Attachment 9
NRC3-12-0003
(17 pages)

Response to RAI Letter No. 70
(eRAI Tracking No. 6244)

RAI Question No. 03.07.01-7

Figure 3.7.1-259 Comparison of Fermi 3 RB/FB and CB SSI FIRS with the NUREG/CR-0098 (Reference 3.7.1-210) median rock spectral shape and enveloping NUREG/CR-6728 (Reference 2.5.2-255) CEUS spectral shape, both scaled to a minimum PGA of 0.1g. All spectra are for 5 % damping.

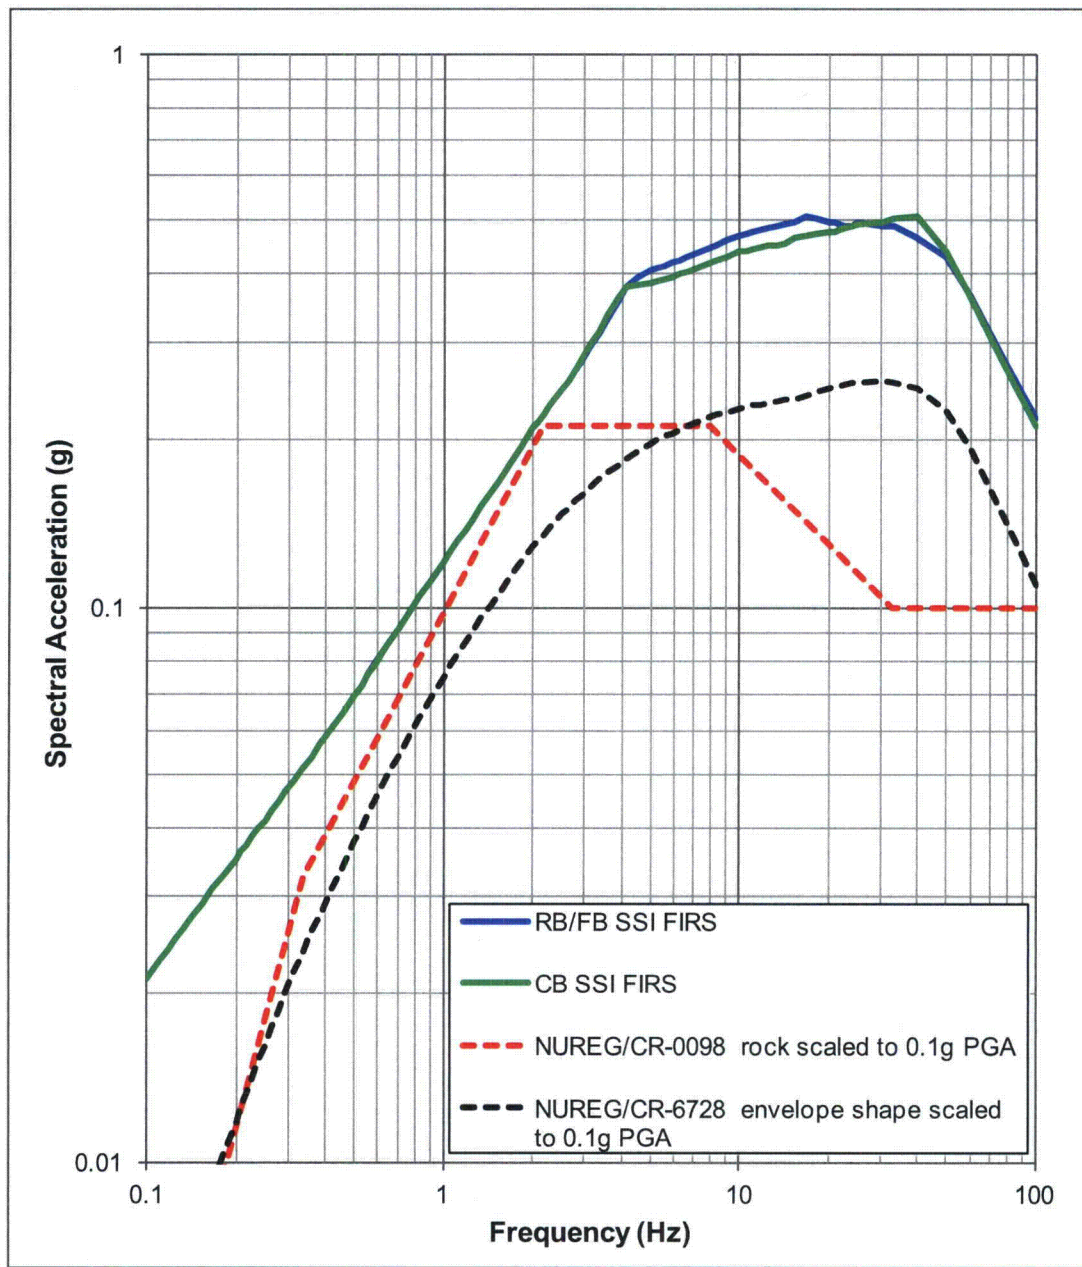
However, the guidance in SRP 3.7.1 and ISG-017 also indicates that, to satisfy the regulatory requirements, the minimum horizontal PGA of 0.1g should correspond to a smooth broad-band spectral shape such as the one described in RG 1.60. Therefore, the applicant is requested to provide in the FSAR comparison plots of the RB/FB and CB horizontal FIRS with the RG 1.60 horizontal spectrum anchored at 0.1 g, which demonstrate that the RB/FB and CB horizontal FIRS envelope the RG 1.60 spectrum at all frequencies of interest. The staff needs this information to confirm that the site-specific seismic input used in the site-specific SSI analysis meets 10 CFR Part 50, Appendix S.

FSAR Subsection 3.7.1.1.4.6, FSAR Subsection 3.7.1.4, and new FSAR Figure 3.7.1-259 are revised as shown on the markup included in the response to RAI 03.07.01-6.

Figure 1: Spectral ratios for 2% damping over 5% damping and 10% damping over 5% damping developed from the NUREG/CR-6728 CEUS rock site time history database.

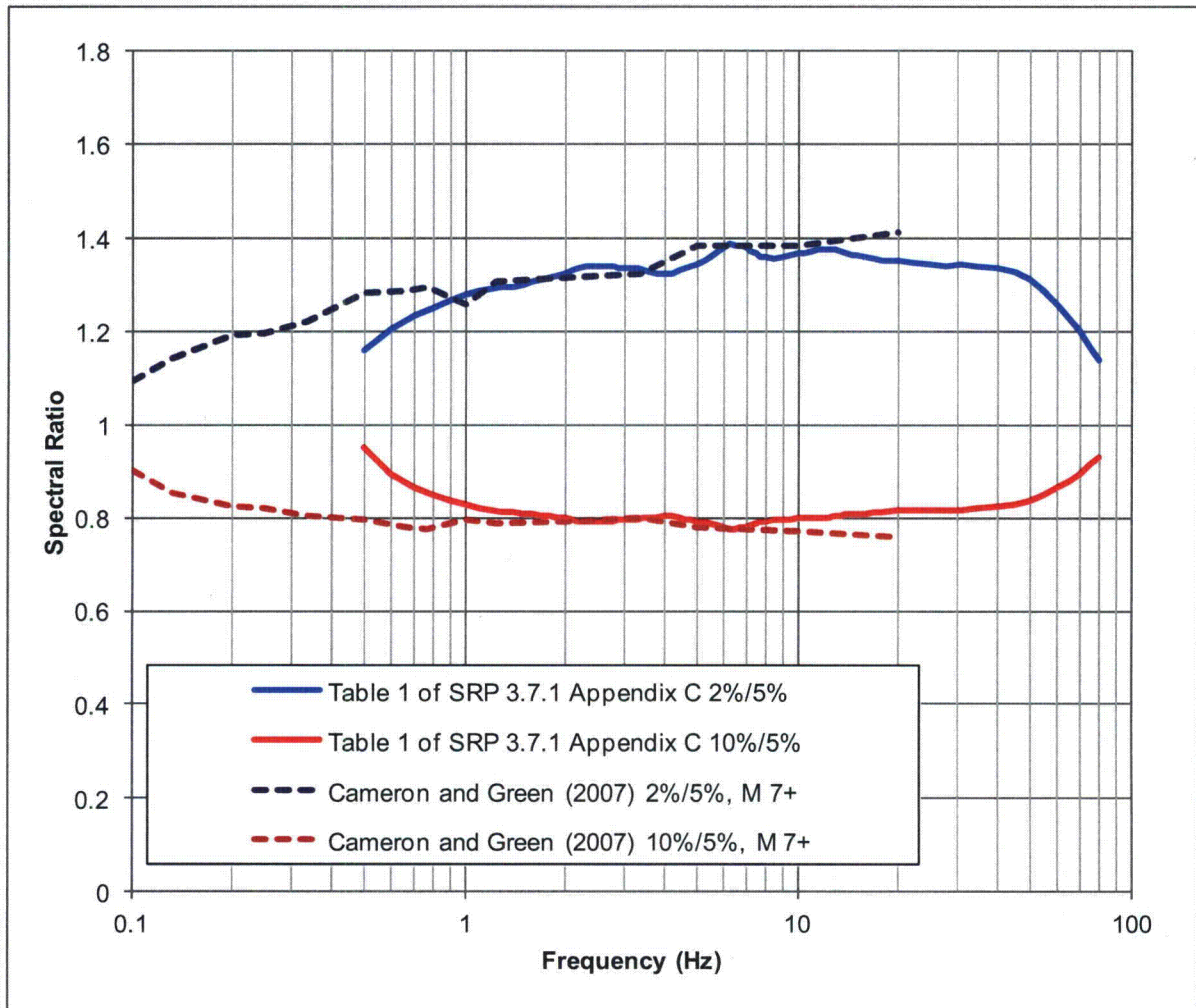
SRP Acceptance Criteria 3.7.1.II.1B also specifies that PGV/PGA should be consistent with the characteristic values for the controlling earthquake. As such, the applicant is requested to provide further justification of the acceptability of the PGV/PGA values for the artificial time histories being higher than the selected controlling earthquake. The applicant is also requested to provide comparison of the response spectra of the artificial time histories and the estimated target spectra (SSI FIRS) at 2 percent and 10 percent damping values for RB/FB and CB.

The values listed in Table 1 of SRP 3.7.1 Appendix C represent averages of the spectral ratios obtained for recordings in all magnitude and distance bins. As shown on Figure 1, the spectral ratios trend towards unity as the spectral frequency decreases below 1 Hz. This reflects the range in magnitudes – including numerous recordings from magnitudes less than 6 – represented in the database. The effect of damping on spectral ordinates at low frequencies is magnitude dependent (e.g., Bommer and Mendis, 2005; Cameron and Green, 2007). Cameron and Green (2007) have performed a similar analysis to that described in SRP 3.7.1 Appendix C with the modification that separate scale factors are computed for the different magnitude bins. The Fermi 3 site hazard at low spectral frequencies is due to large magnitude earthquakes (see FSAR Table 2.5.2-219) and the seed time histories used to develop the SSI input time histories are recordings of the **M** 7.6 1999 Chi-Chi, Taiwan, earthquake. Also shown on Figure 1 are the spectral ratios developed by Cameron and Green (2007) from **M** 7+ recordings in the NUREG/CR-6728 CEUS rock site time history database. The Cameron and Green (2007) **M** 7+ ratios are similar to those from Table 1 of SRP 3.7.1 Appendix C for frequencies above 1 Hz. At frequencies below 1 Hz, the Cameron and Green (2007) **M** 7+ ratios do not trend towards unity. They show a stronger damping effect than those from Table 1 of SRP 3.7.1 Appendix C. This effect results from the greater energy content at low frequencies in recordings from larger magnitude earthquakes. This effect is reduced in the spectral ratios of Table 1 of SRP 3.7.1 Appendix C by including a range of magnitudes. Both sets of spectral ratios were used to develop estimated SSI FIRS for 2 percent and 10 percent damping in the following comparisons; however, the Cameron and Green (2007) spectral ratios are considered more appropriate because of the earthquake magnitude associated with the SSI FIRS time histories. These estimated FIRS are developed only for the frequency range contained in the two sets of spectral ratios (0.1 to 20 Hz for the Cameron and Green spectral ratios and 0.5 to 80 Hz for the SRP spectral ratios). Based on the fact that there is little to no difference between the spectral ratios for CEUS horizontal and vertical motions presented in Appendix C of SRP 3.7.1,
